Metropolitan Historic Zoning Commission
Sunnyside in Sevier Park
3000 Granny White Pike
Nashville, Tennessee 37204
Telephone: (615) 862-7970
Fax: (615) 862-7974

STAFF RECOMMENDATION
2701 Woodlawn Drive
November 15, 2017

Application: New construction – addition and outbuilding
District: Hillsboro-West End Neighborhood Conservation Zoning Overlay
Council District: 18
Map and Parcel Number: 10415041700
Applicant: Manuel Zeitlin
Project Lead: Melissa Baldock, melissa.baldock@nashville.gov

1 **27TH ELEVATION**
1/8" = 1'-0"

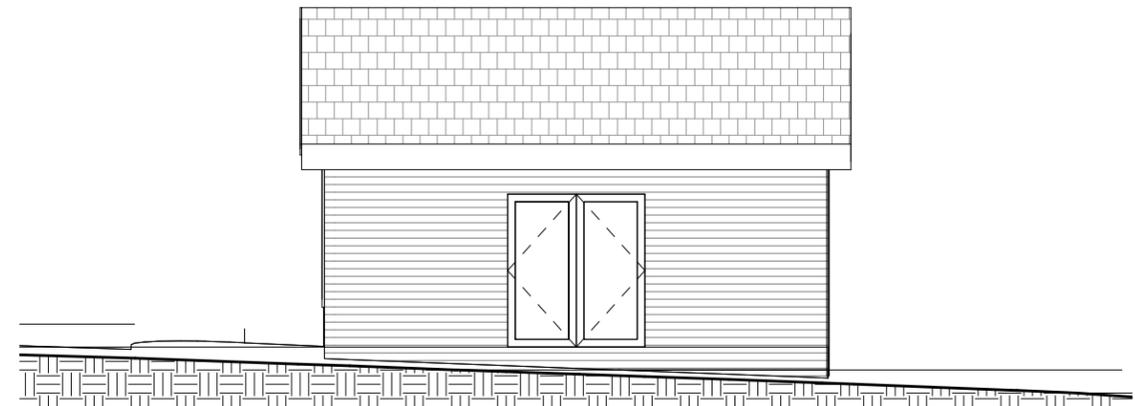
Proportion and Rhythm of Openings: No changes to the window and door openings on the existing house were indicated on the plans. On the 27th Avenue South elevation, all the windows are vertically oriented. However, there is an expanse of fourteen feet (14’) without a window or door opening. Staff finds this to be acceptable because it is at the back of the addition and is on a wall that is pushed back twenty-two feet (22’) from the main wall of the addition. On the right elevation, there is an expanse of twenty-three feet (23’) without a window or door opening. Staff finds this to be appropriate because there is not on a street-facing façade and because the expanse does not start until over sixty-three feet (63’) from the front of the house. It will not be highly visible from the street. Staff recommends that all window openings with two or more windows have a four to six inch (4”-6”) mullion in between the window. With this condition, staff finds the project’s proportion and rhythm of openings to meet Sections II.B.1.g. and II.B.2. of the design guidelines.

1. Staff approve the final details, dimensions and materials of windows and doors prior to purchase and installation;
2. Staff approve the roof color, dimensions, and texture;
3. All window openings with two or more window have a four to six inch mullion in between them; and
4. The HVAC be located behind the house or on either side, beyond the mid-point of the house.
